QUALITY ASSURANCE -- NON-CONFORMANCE REPORT

Report No: NCR-000339

Component: Crossbeam 10

Reference Description: Excessive Root Opening

Description of welding discontinuity:

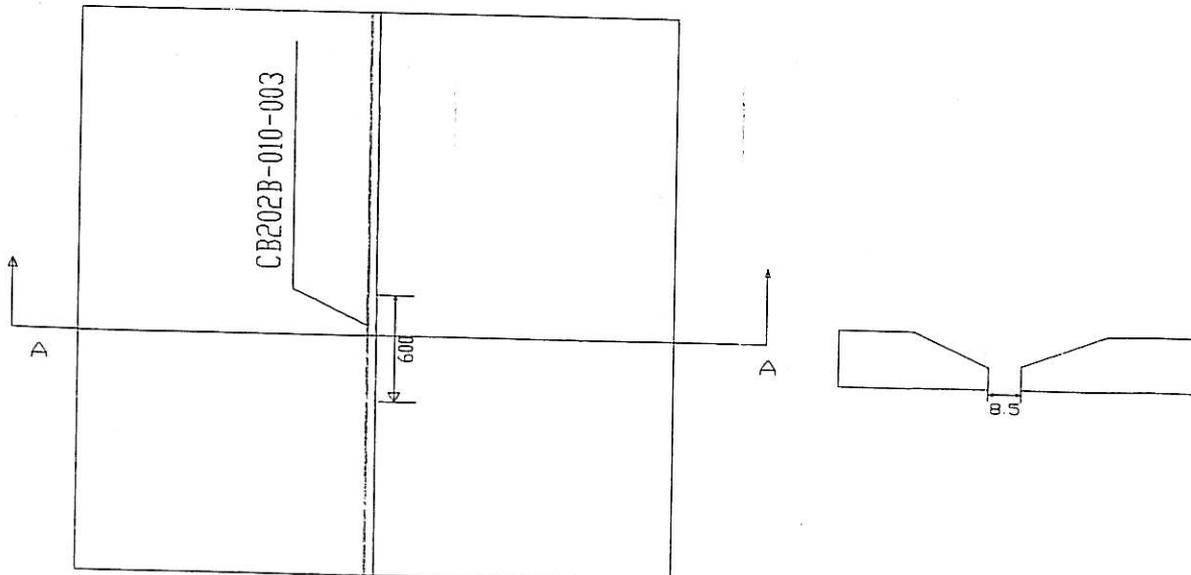
施建刚施工队CB10上的焊缝CB202B-010-003装配点焊后发现有一段根部间隙过大间隙为7到9毫米

The gap was 7-9mm at CB10 weld CB202B-010-003 after tack weld, which fabricated by work team: Shi Jiangan.
